15B Failure Modes and Effects Analysis (FMEA)

The information in this appendix of the reference ABWR DCD, including all subsections, tables, and figures, is incorporated by reference with the following departures.

Figure 15B-1 Simplified CRD System Process Flow Diagram

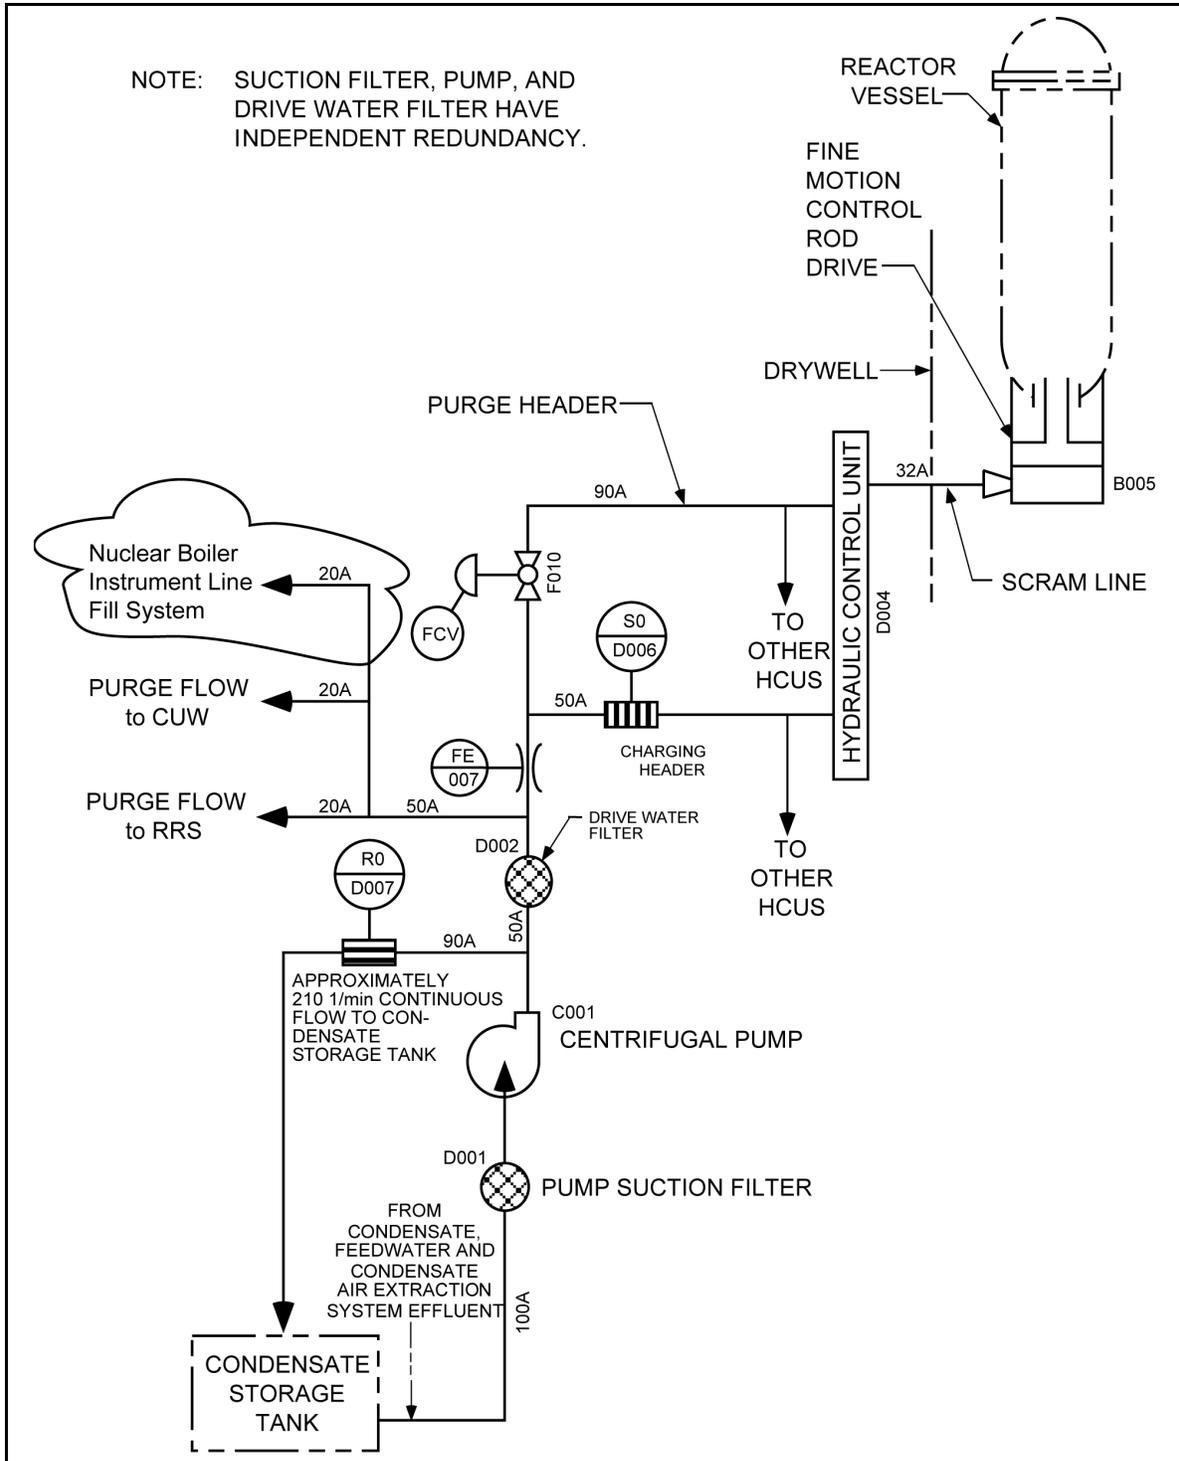
STD DEP 7.7-1 (Figure 15B-1)

STD DEP 7.7-1
